Final

Radiological Site Investigation Report, 1400 Series Housing Area

Installation Restoration Site 12

Former Naval Station Treasure Island, San Francisco, CA

Figure 2

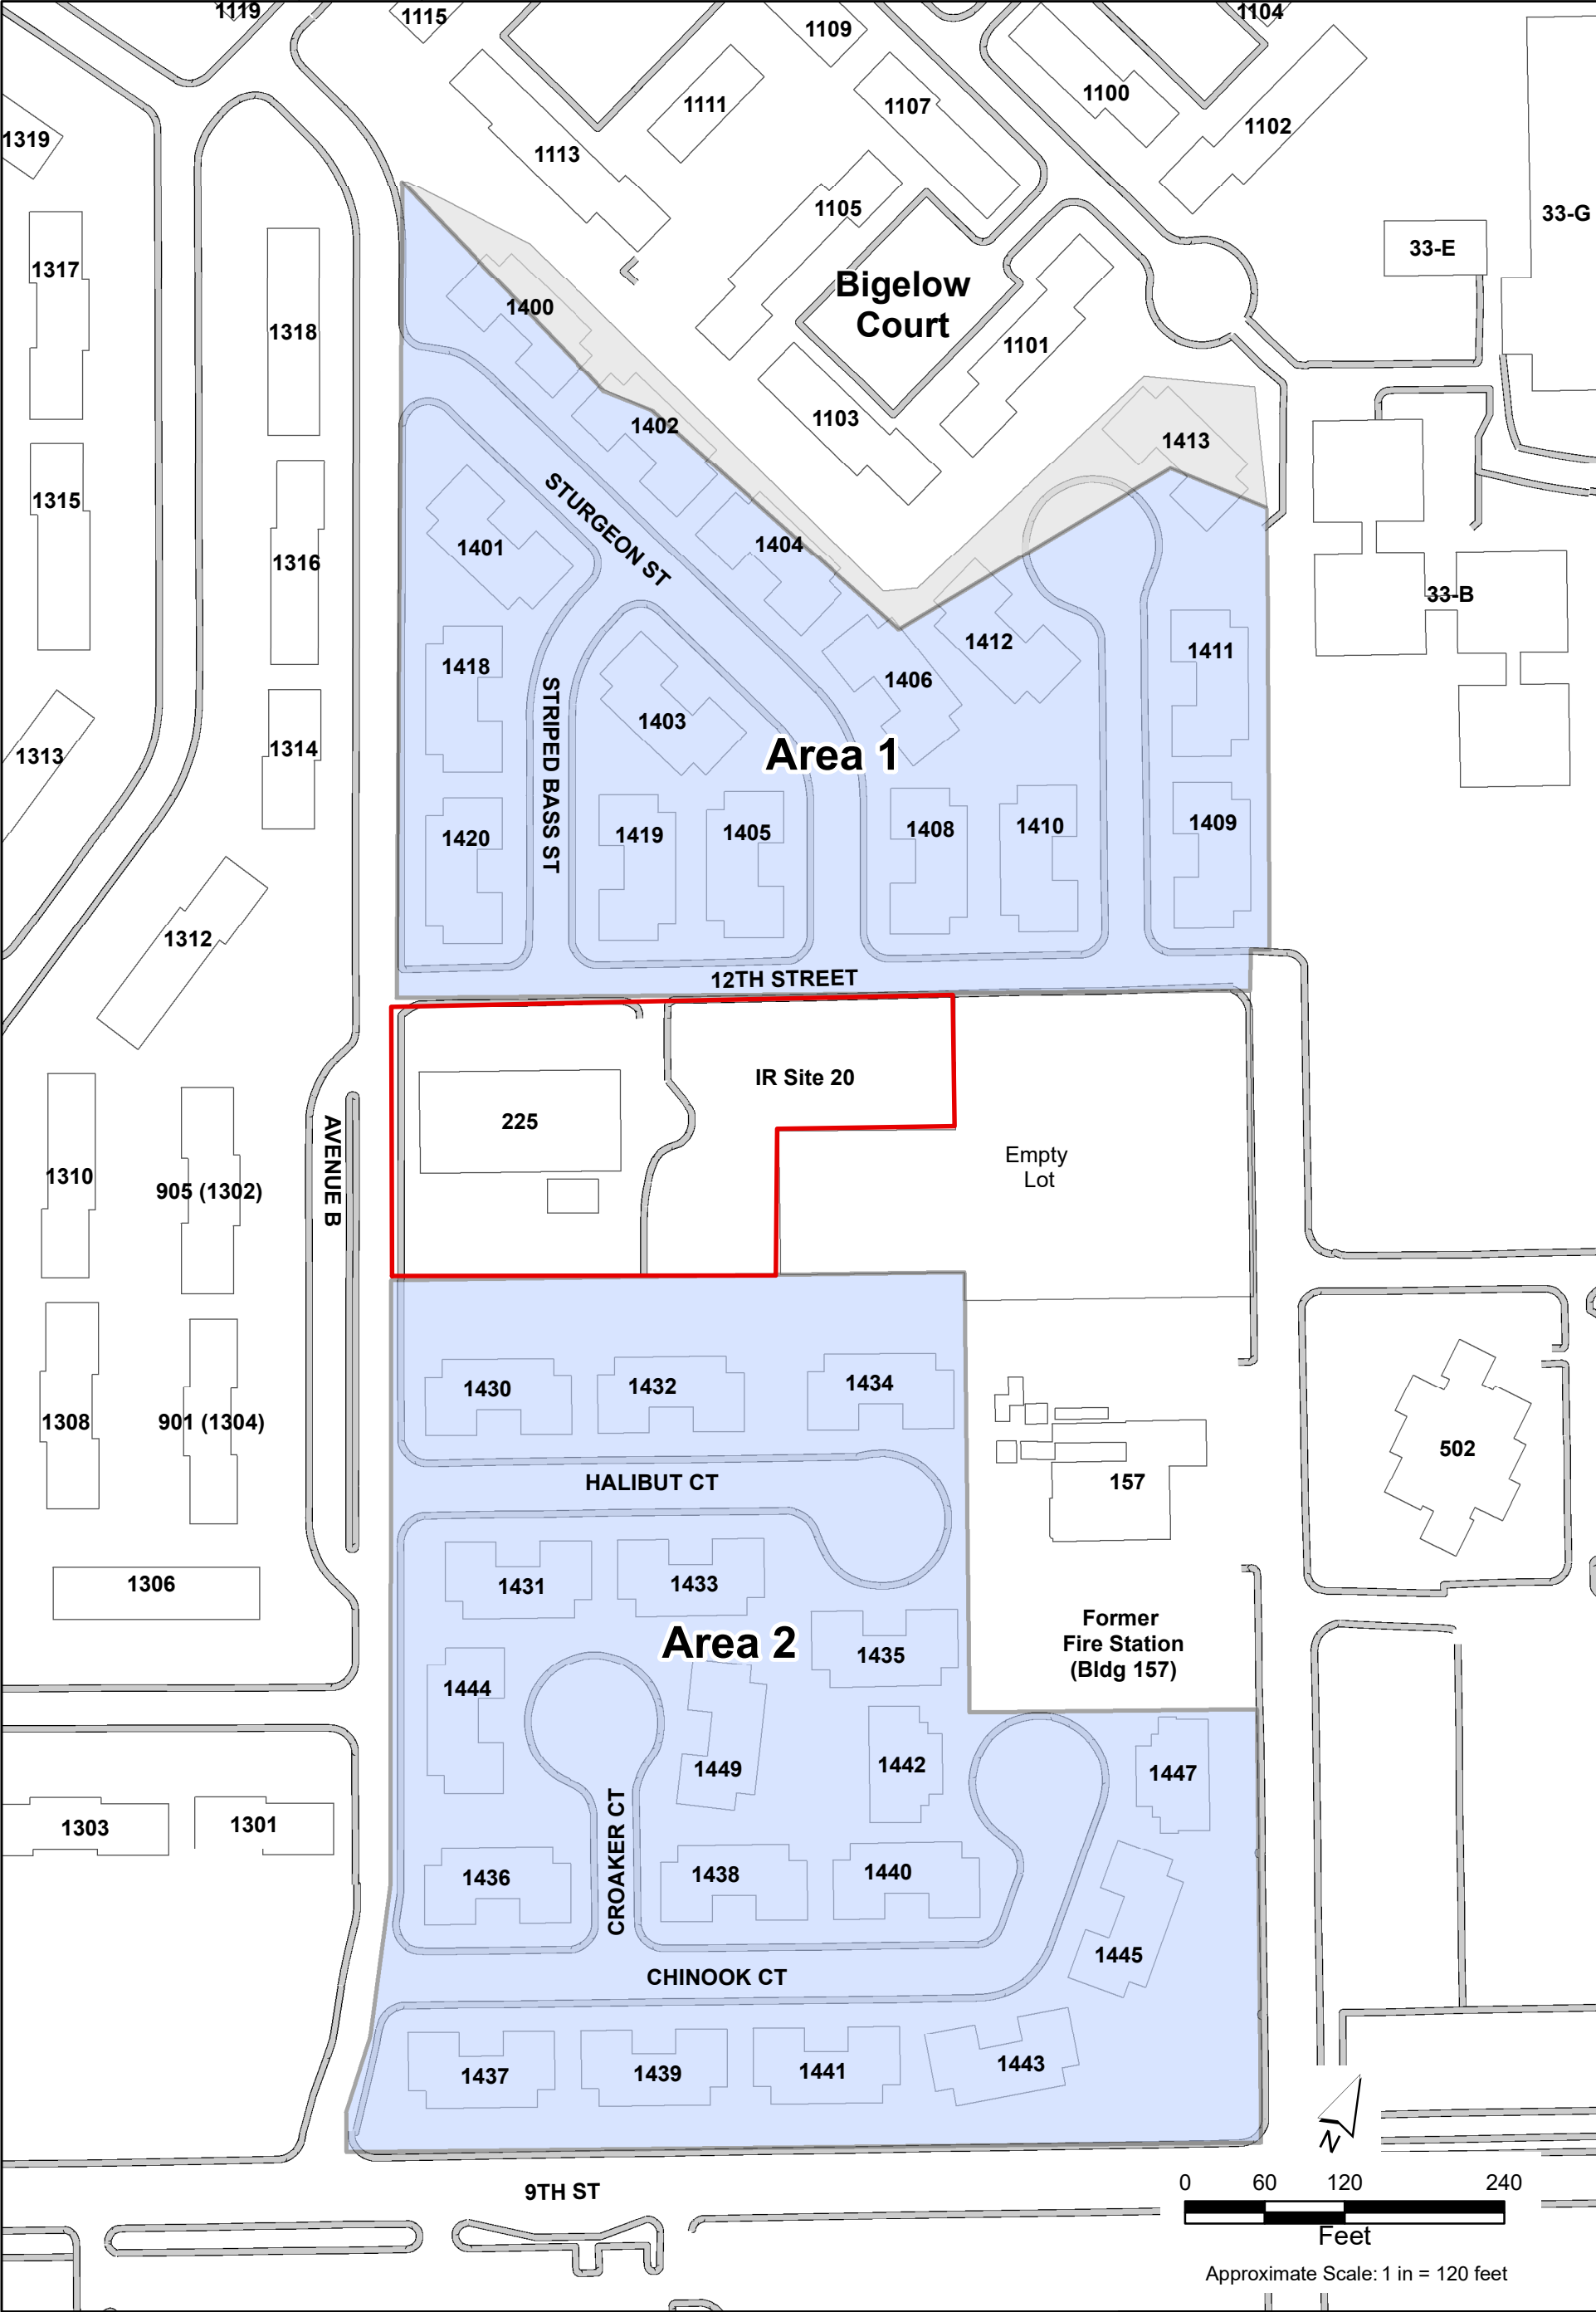
| 5. | Figure 2: Please indicate on this figure that the space adjacent to IR Site 20 (in between Area 1 and Area 2) is the empty lot mentioned in Section 1.4. | A note has been added to Figure 2. Section 1.4 also refers to Figure 3 that specifically calls out features and boundaries at and around the 1400 Series Housing Area, including the empty lot between Areas 1 and 2. |
